FINAL CR Kendall Mine Closure Environmental Impact Statement

State of Montana
Department of Environmental Quality

April 2016

Response to Comments

Completed areas within the Kendall Pit.

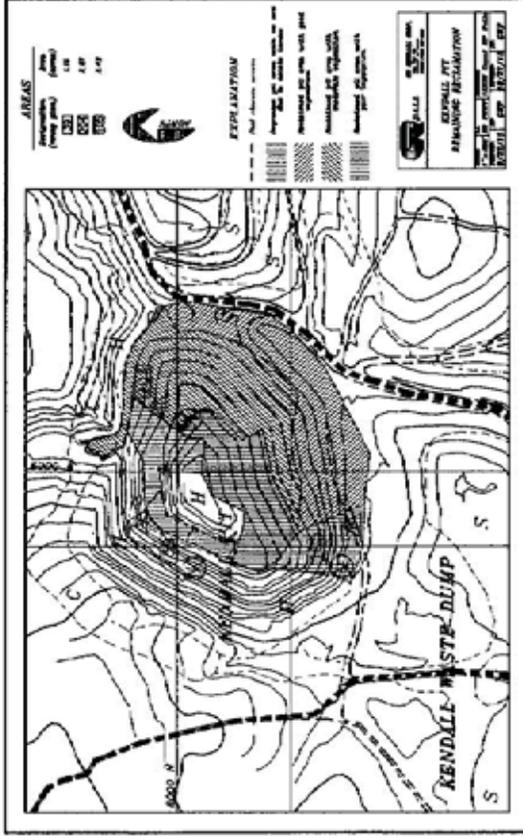
highwall, falling debris was a safety concern and will likely cover any soil placed there. Area 105 totals 2.42 acres comprising slopes of less than 2:1 which cannot be reduced due to composition of the highwall. Area 204 totals 2.09 acres and cannot be completed because any further slope reduction will compromise the Mason Canyon drainage. Unlike the Muleshoe pit, The Kendall pit was not re-graded prior to publishing the Soils and Revegetation Plan and as such, Schafer could not accurately determine the total of what could be completed.

Soil placed in the Kendall pit was generally considered the poorest remaining on site. Those soils originated from stockpiles TS-4 and TS-21. TS-4 originated, in part, from stockpile TS-13a, the same source as proposed to be used in any future soil placement. This soil was separated from TS-13a during the grading of the upper Kendall waste dump runoff bench after it was determined that drainage ran through TS-13a. If this resource is not performing as it should in the pit now, will placing more above be of any beneficial use?

DEQ has watched the reclamation and revegetation success in the pits over the years. It is true the revegetation has been slow to start but eventually revegetation has been successful. The Horseshoe Pit revegetation is the best example of the success of revegetation in the pits over time.

DEQ addressed the Kendall and Muleshoe pit concerns in 2008 in a June 18th inspection report sent to CRK: "Areas with limited growth should be 1) re-soiled, amended with an agency approved organic amendment, reseeded, and/or planted with Ponderosa pine (Pinus ponderosa); or 2) amended with an agency approved organic amendment, reseeded, and/or planted with Ponderosa pine (Pinus ponderosa)."

FIGURE A-4
CR Kendall Mine
Arsenic, Selenium, and Thallium Levels in
Mason Canyon Groundwater
(TMW-24A)

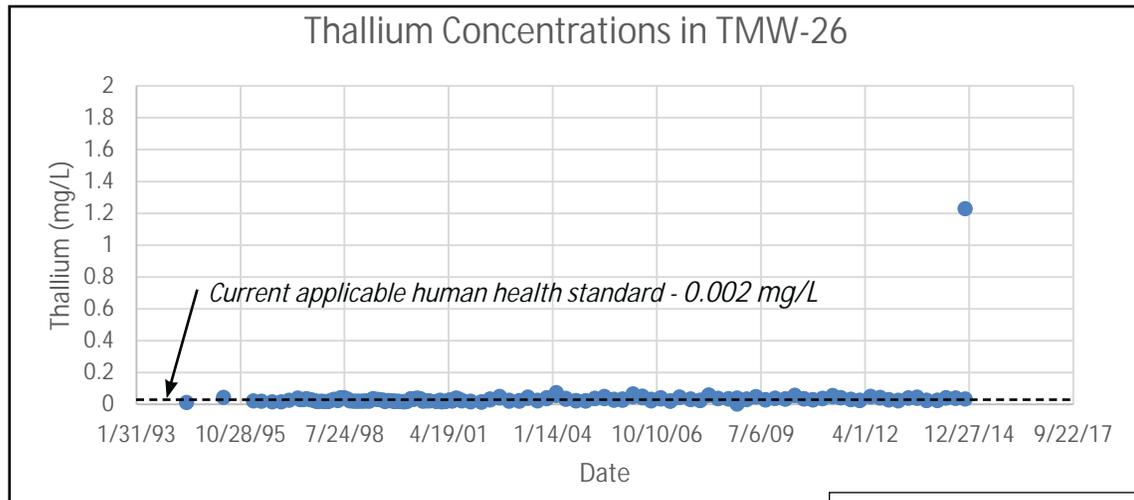
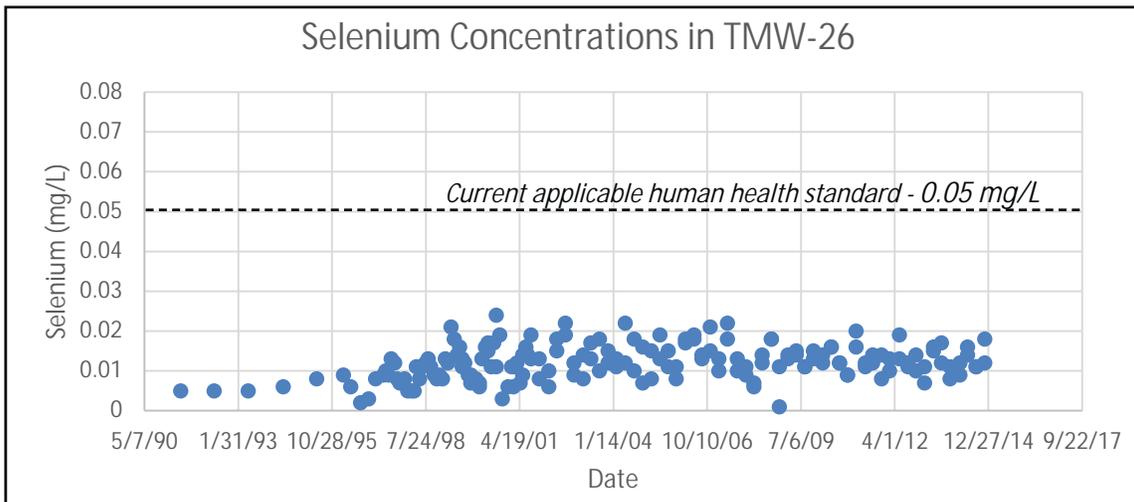
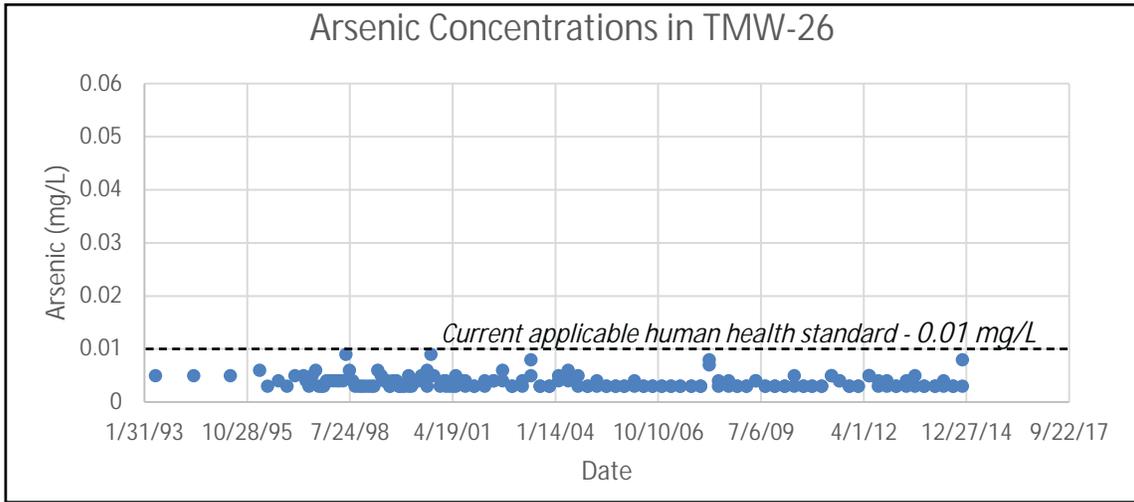
The monitoring wells demonstrate that water continues to exceed standards in surface water and groundwater monitoring wells, including Mason Canyon groundwater at TMW-24A (Figure A-4); and Mason Canyon surface water KVSW - 4 (Table 3-10, P. 3-20), surface water in Barnes King Gulch (KVSW-3) (Table 3-12, p. 3-22), groundwater in Barnes King Gulch (TMW-30A)(Table 3-22, p. 3-30), and the Section 29 spring (Table 3-15, p. 3-25).

Well TMW-24A (Figure A-4) in lower Mason Canyon has shown elevated arsenic concentrations since the late 1990s, with a trend of improving quality over the past 8 years. This arsenic does not appear to be derived from the CR Kendall mine site, as all shallow groundwater within the Process Valley drains through the underdrain into collection sump TMW-26, and this water has consistently remained within water quality standards for arsenic. During construction of the leach pads, historic tailings were removed from the process valley; however, deposits of tailings remain present downgradient of the CR Kendall mine site, and the arsenic detected in TMW-24A is suspected to be related to the presence of these tailings. Similar arsenic concentrations have been observed over many years in lower Barnes-King Gulch, where surface water flows through historic tailings.

FIGURE A-9
CR Kendall Mine
Arsenic, Selenium, and Thallium Levels
in South Fork Little Dog Creek Pumpback
Water (KVPB-6)

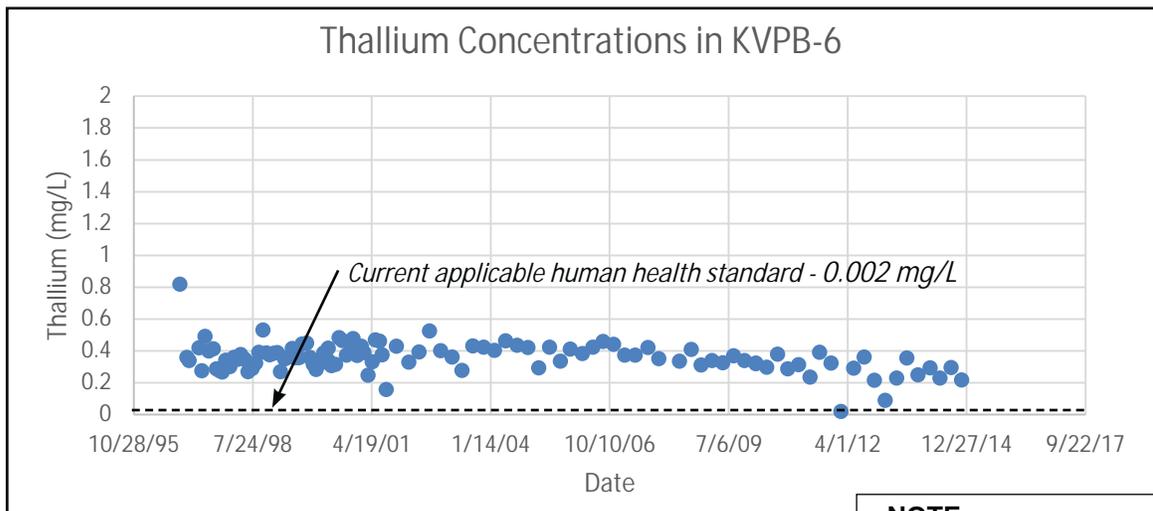
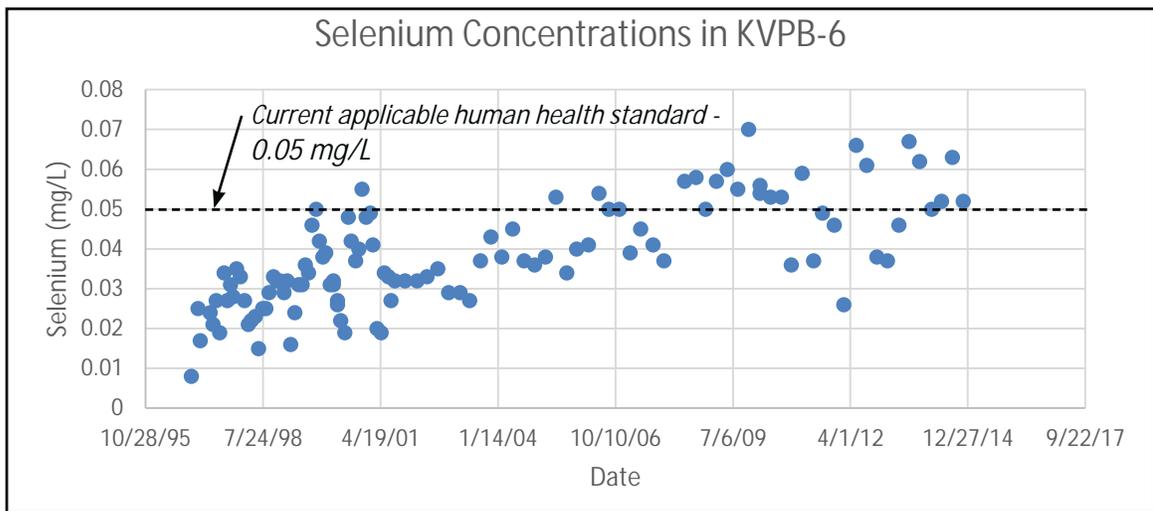
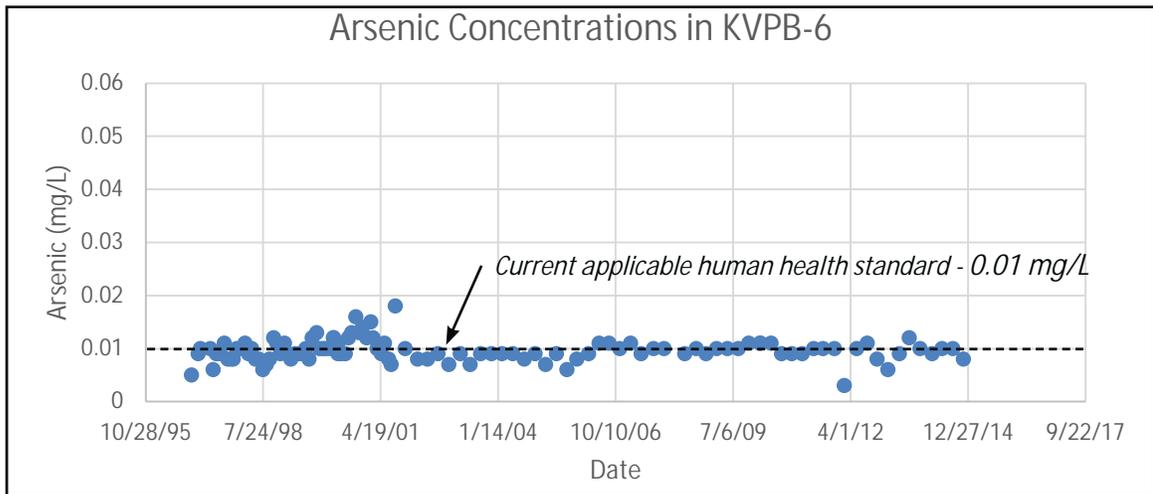
The pumpback data for KVPB-6, which captures alluvial groundwater from the Muleshoe waste rock pile, clearly shows concentrations of selenium in the pump back system in the South Fork of Little Dog Creek drainage above standards (Figure A-9, DEIS). The water quality exceeds human health standards for arsenic 50% of the time; thallium 100% of the time; selenium 23% of the time, and nitrates 62% of the time (Table 3-25). Thallium concentrations in KVPB-6 in 2014 were still 100 times the standard. Furthermore, it isn't certain whether water quality is improving in KVPB-6.

especially A-7, A-8, and A-9 indicate that the pollution levels are as bad as in 1995 or with the Selenium actually significantly worse. We have observed that if it is drier the contaminate levels are higher due to more concentration. We assume this is why you are allowing CR Kendall to take Spring Water which was designated by Water Rights for augmentation to the Little Dog Drainage and divert a part of it to the KVPB-6 as indicated on the Figure 2-2 piping chart. We are assuming the meter for water being sent down the pipe is at the Little Dog Creek Spring so water being diverted into the pumpback is being shown as being returned to the drainage. I can imagine no reason to divert clean spring water into the system other than to try to dilute contaminated water. We believe part of the problem with the KVPB 6 is the use of the LAD system, which has continually for over 20 years deposited more contaminants on the dump thus creating a vicious cycle. These pollutants will probably only continue to get worse as the LAD is allowed to continue for the next 100 years. Wayne Jepsen told us in March that this was an emergency LAD but if that is so what was the emergency last week.

Figure A-9 presents water chemistry from pumpback system KVPB-6, located below the North Muleshoe waste rock dump in Little Dog Creek. The data from this location shows a slight decrease in average arsenic concentrations over the period of record and a more substantial decrease in thallium concentrations. The concentration of selenium has increased at this location, from an average of about 0.025 mg/L in 1996 to an average of about 0.06 mg/L at present. The graph also indicates that the selenium concentration at this seepage collection system does not appear to have increased since approximately 2007.
